**PLANNED UNIT DEVELOPMENT  
& SUBDIVISION STAFF REPORT**

**Date: December 20, 2007**

**DEVELOPMENT NAME** Perch Creek Preserve

**CONTEMPLATED USE** Planned Unit Development Approval to allow a gated, 18'-wide, aggregate-surfaced private street single-family residential subdivision with reduced lot widths and sizes, reduced front and side setbacks, and increased site coverage of 50%.

# SITE PLAN

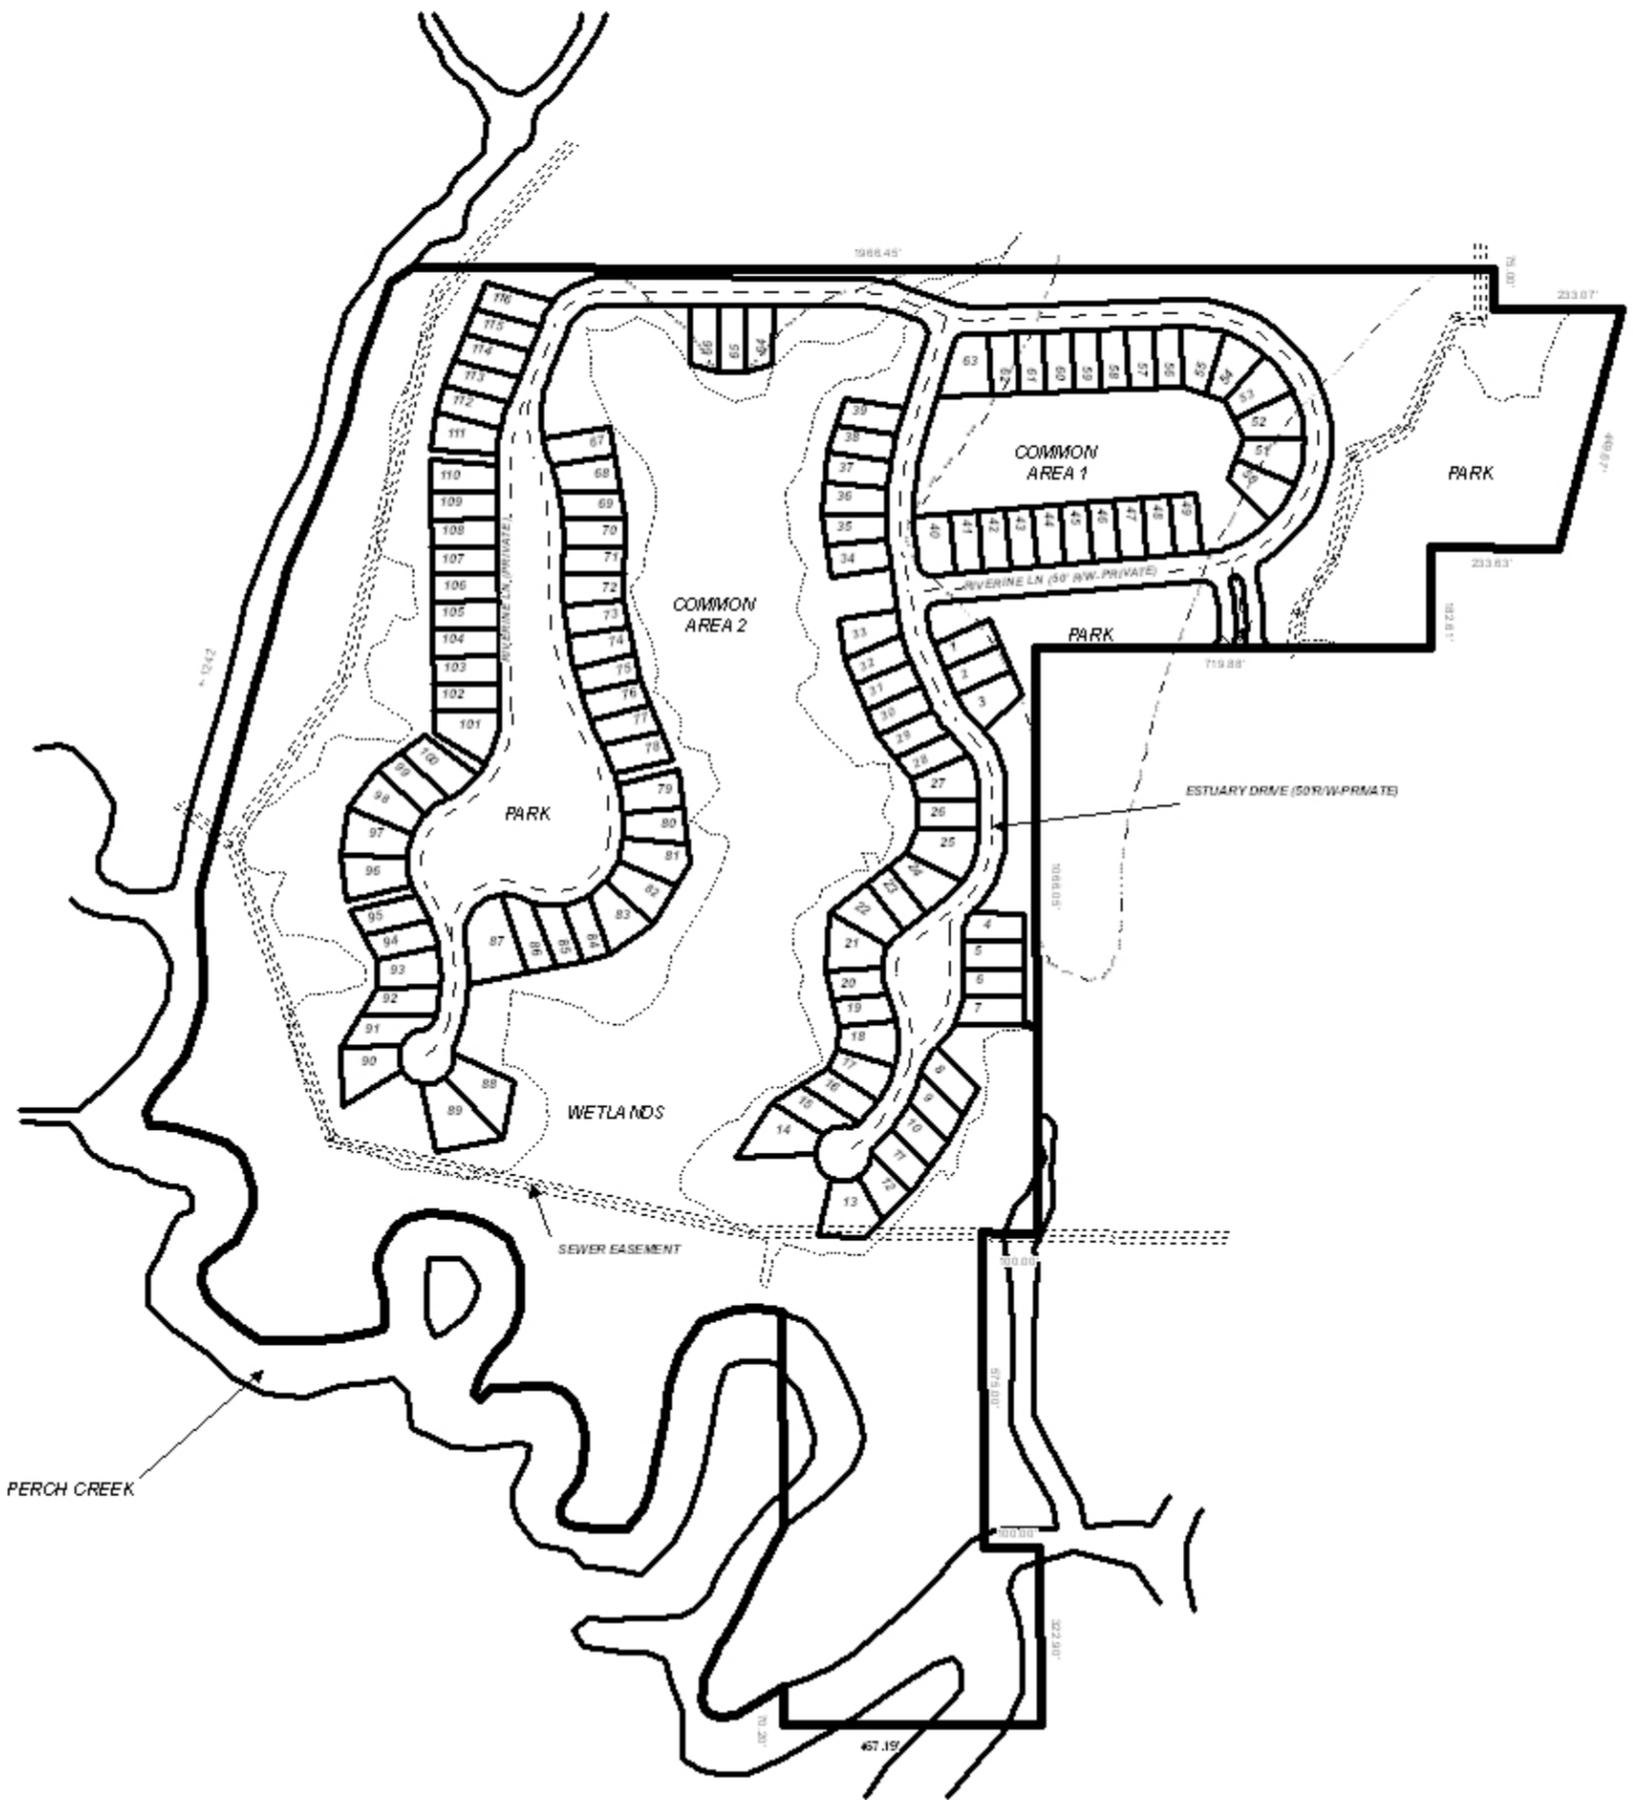
Another issue is that the development proposes a 50' private street right-of-way, as required by the Subdivision Regulations. However, the streets are proposed to be 18' streets with a ribbon curb (the regulations require two 2' asphalt wings), and 14' one way lanes. The surfacing is proposed to be aggregate, instead of the minimum standard asphalt paving required in the Subdivision Regulations. The issues here relate to MFD requirements, based upon the 2003 International Fire Code (Section 503 which states that the minimum width of an apparatus access street is to be 20', and where adjacent to a hydrant the minimum width is to be 26'), and appendices C & D.

The proposed private streets exceed the maximum length for a cul de sac or closed end street as stated in the Subdivision Regulations, the park areas indicated in the middle of the private street rights-of-ways may be sufficient to allow for a longer cul de sac and allow a fire truck to turn around. However, no information is provided as to the level of clearing and/or improvements there may be in these areas that would address these concerns.

Another issue is that the locations of the one-way and two-way surfaces are not shown on the plan, nor are the areas intended for asphalt or pavers. PUD Approval is site plan specific, therefore the plan should reflect the locations of the one-way and two-way surfaces, and the paving sections.

The plan denotes several areas as "PARK" and others as common area. Neither the narrative nor the plan reference the difference between the two, nor whether the "parks" are to be private or dedicated parks.

4. Revise the plat to illustrate locations of one-way and two-way surfacing, and areas of asphalt paving or pavers;
5. submit justification for aggregate surfacing in lieu of paved surfacing as required by the Subdivision Regulations;

6. Revise the plan to illustrate areas of clearing and/or improvements within the park areas illustrated in the private street rights-of-ways;
7. provide information regarding the areas denoted as "Park", explaining the difference between "Park" and "Common Area", and if the "parks" are to be private or dedicated parks;
